SUPPLEMENT NO. 7 TO PROPOSED CHANGE NO. 145

IMPLEMENTATION INSTRUCTIONS

1. Replace Section 4.0 "Small Break Analysis" of Appendix A to "Yankee Nuclear Power Station Core XIII Performance Analysis" with the corresponding Section 4.0 attached in its entirety (including all tables and figures).

4.0 SMALL BREAK ANALYSIS

FIGURE 4-1
 NODALIZATION FOR YR CORE XIII
 SMALL BREAK ANALYSIS

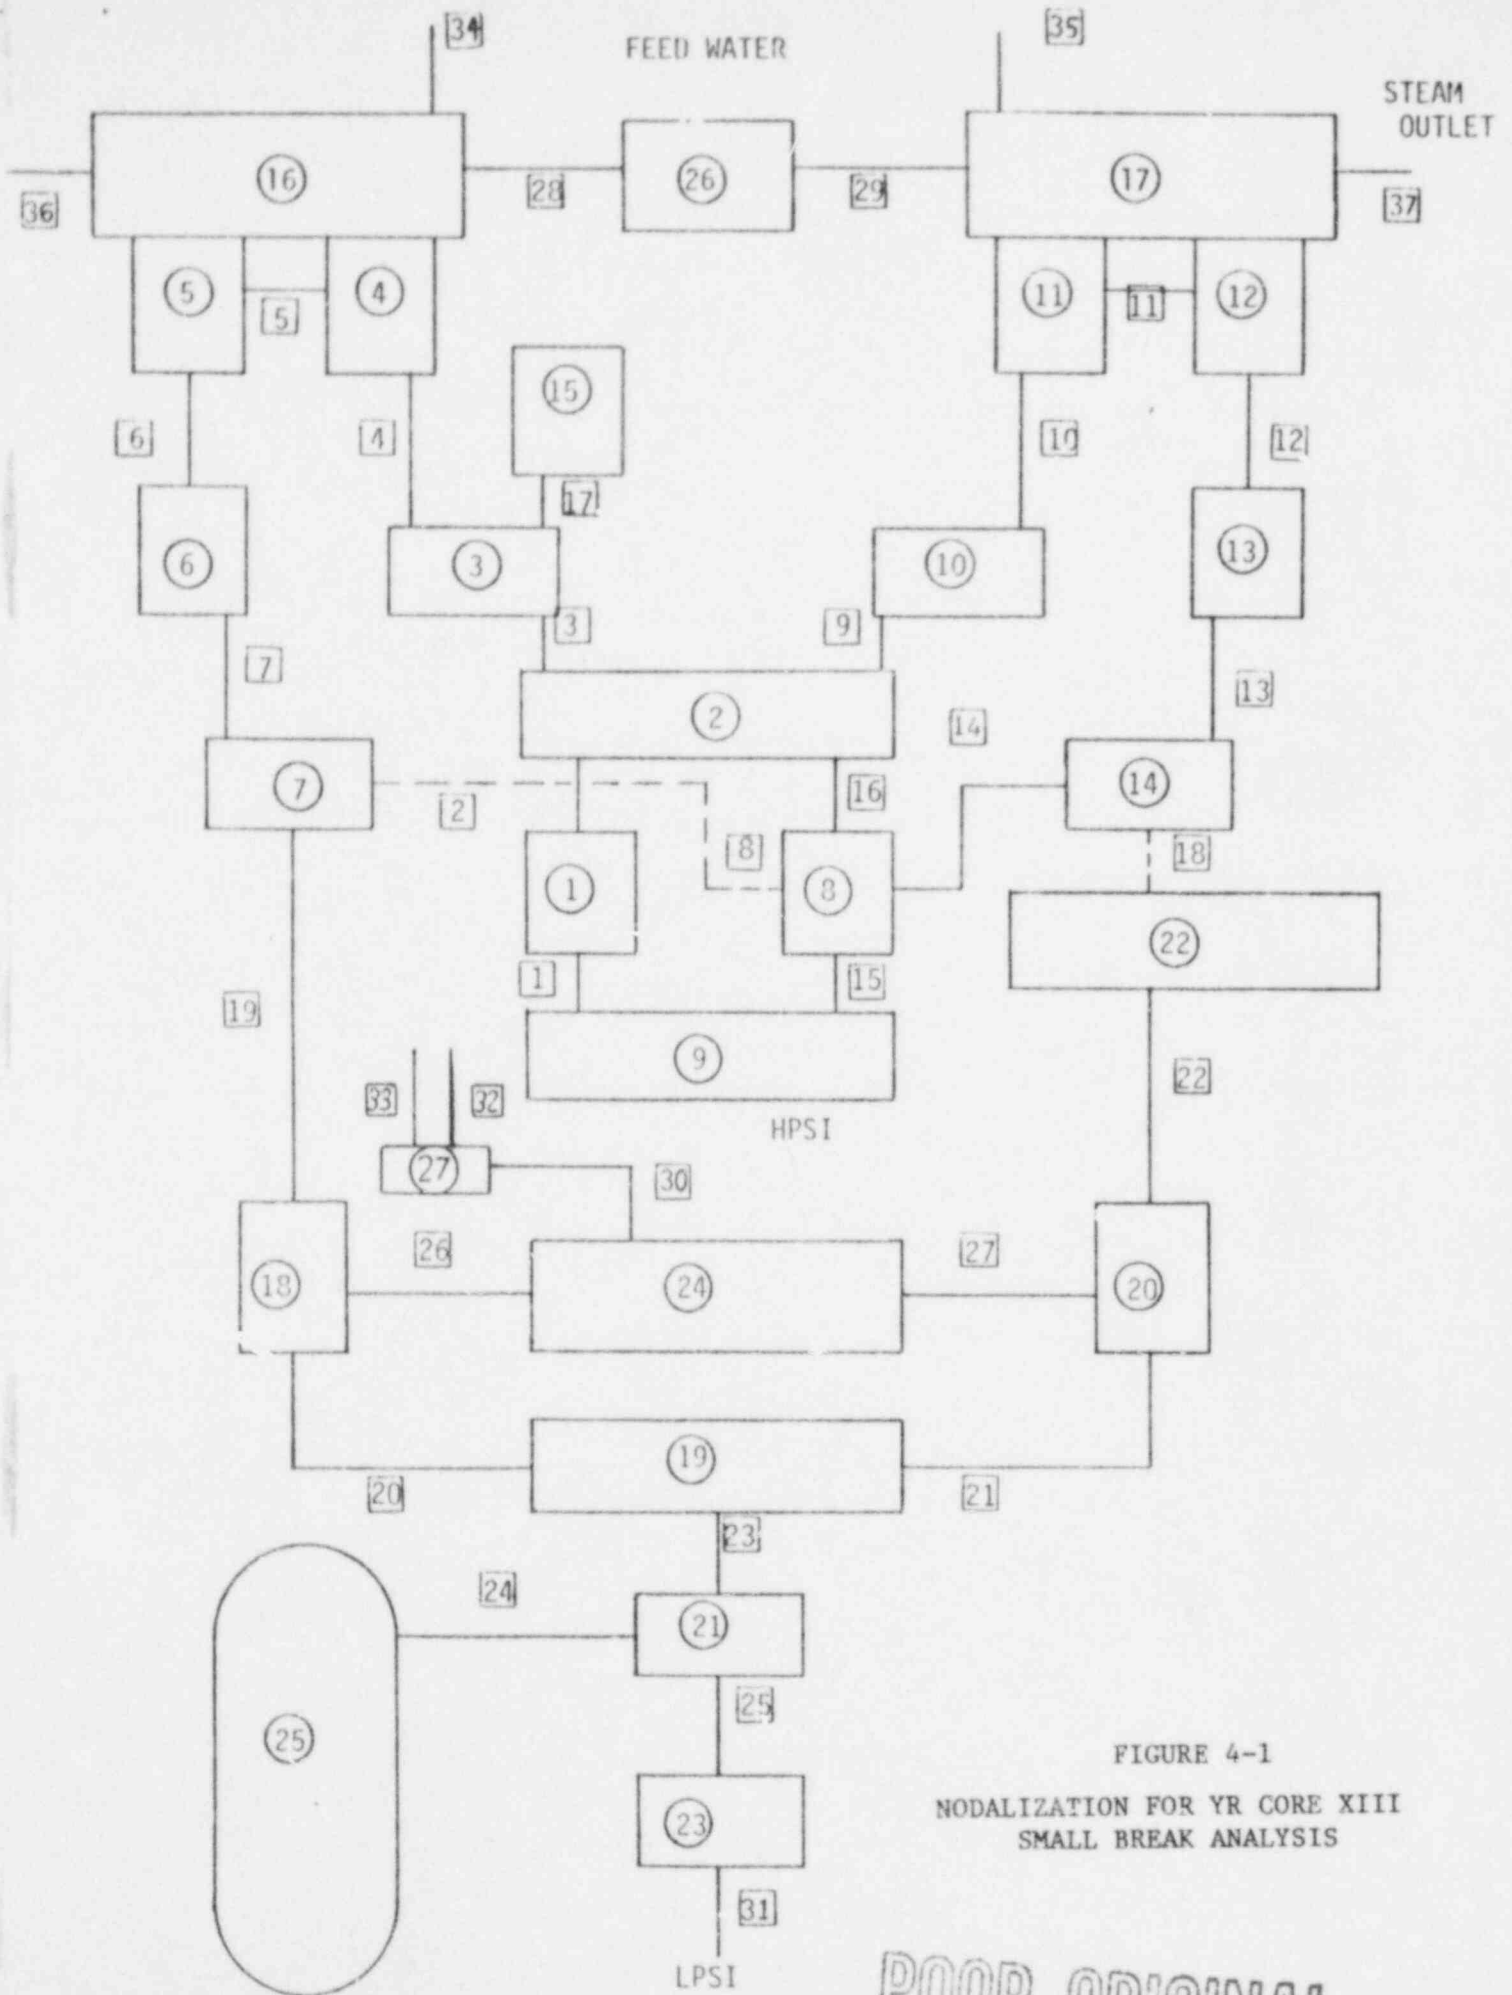
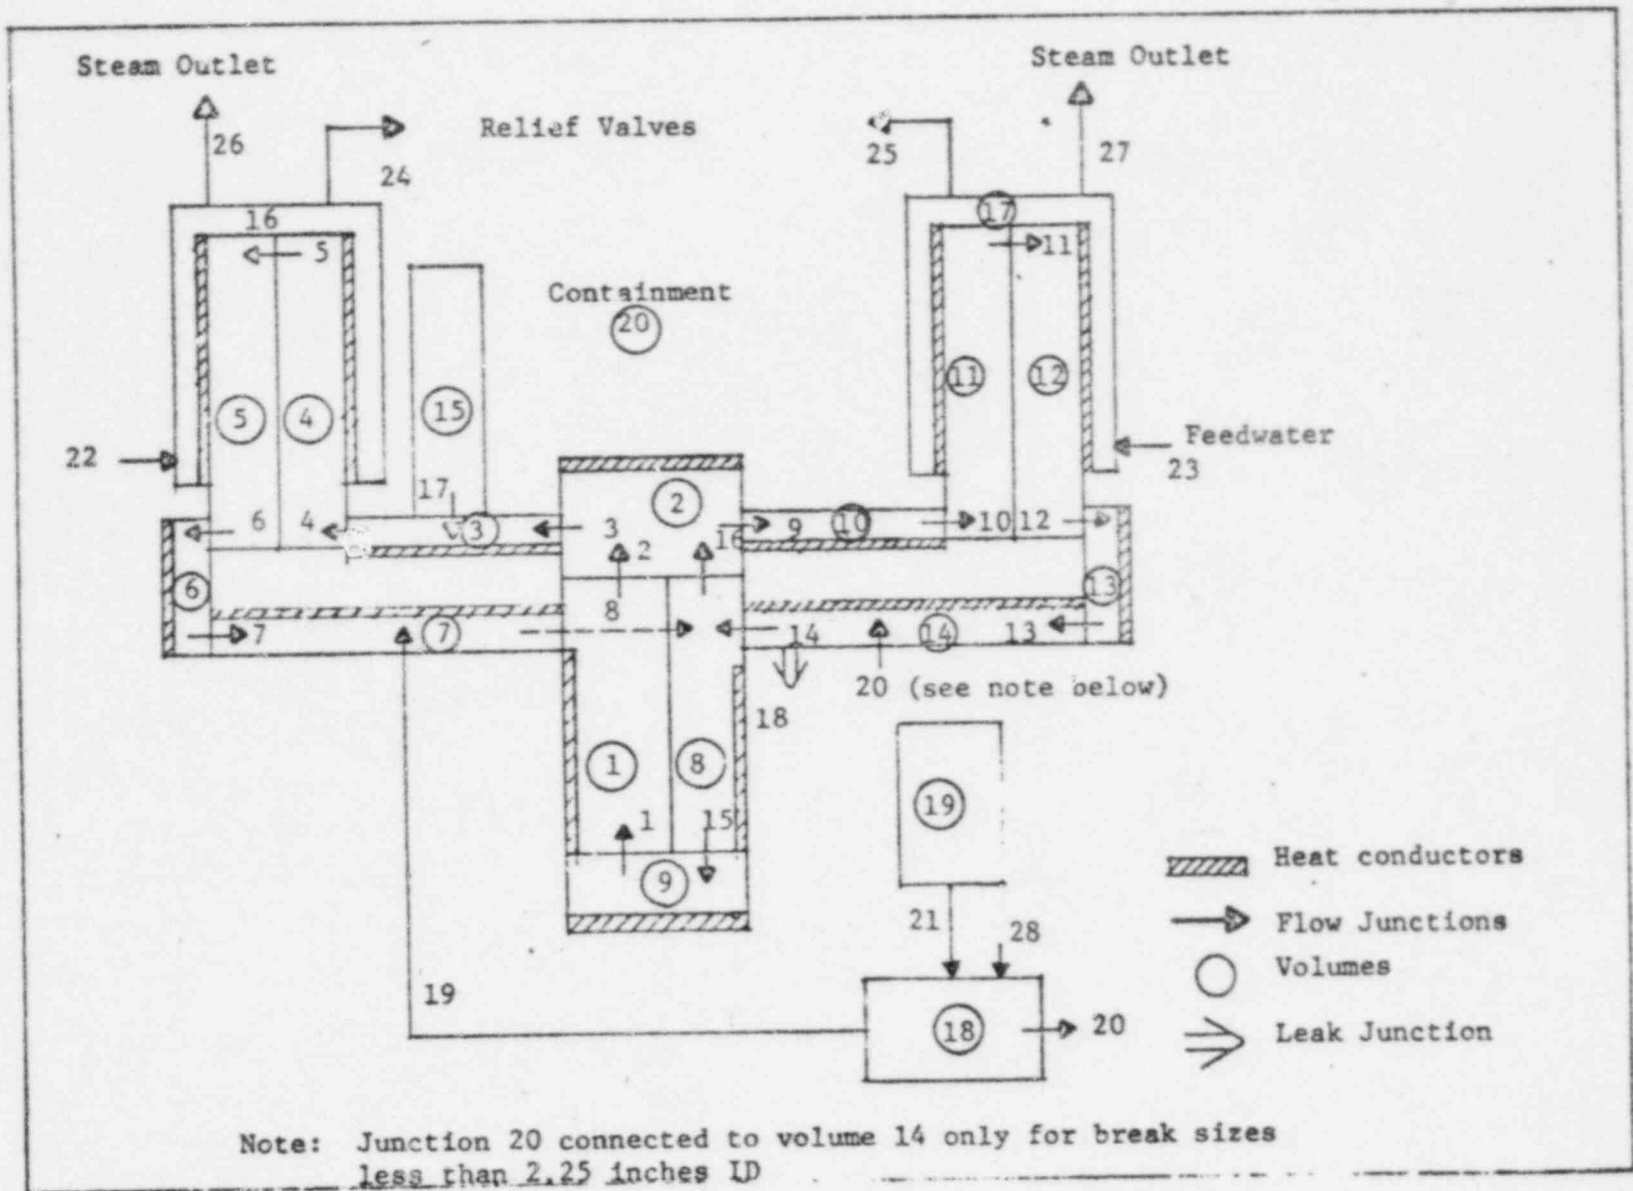
The reactor coolant system was nodalized into control volumes interconnected by flowpaths as shown in Figure 4-1. The broken loop was modeled explicitly while the intact loops were lumped together. This model is identical to the nodalization used in the Core XII analysis excepting:

- (1) changes in the ECCS portion of the model necessary to represent the modified ECCS and
- (2) changes in the ECCS model necessary to accurately reproduce both the results of the most recent LPSI and HPSI pump tests and the 1972 accumulator flow tests. Figure 4-2 provides the Core XII model for comparison.
- (3) changes to the input HPSI fill curves to reflect recent HPSI pump tests. The results of these tests are provided in Figure 4.3. For conservatism and to allow for future potential measurement uncertainties, the minimum

FIGURE 4-3

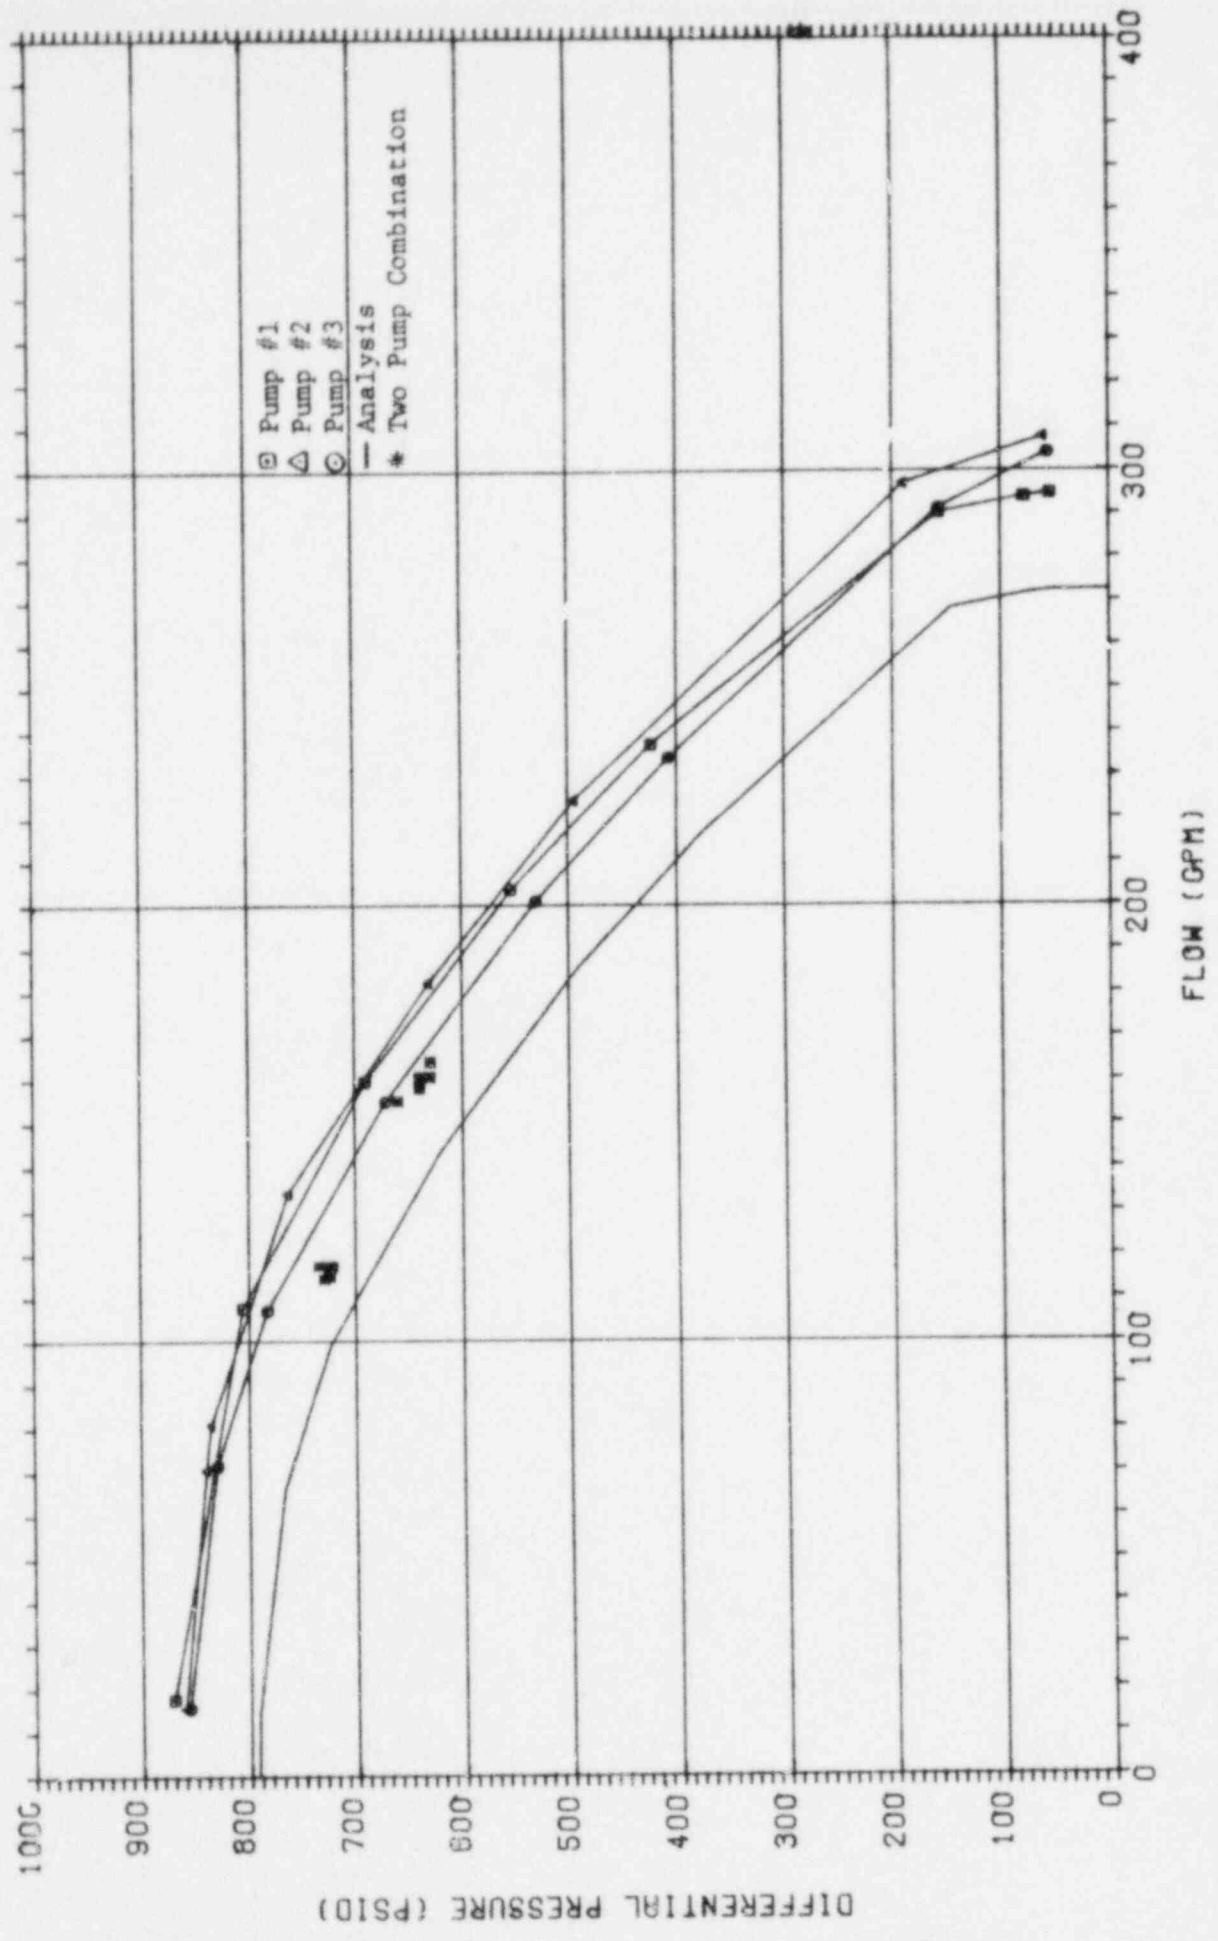
HPSI performance curve (i.e., Pump No. 3 from 790 psid to 160 psid, and Pump No. 1 from 160 psid to runout conditions) was reduced by 7.5% both in flow and head. This revised performance curve is also included in Figure 4-3.
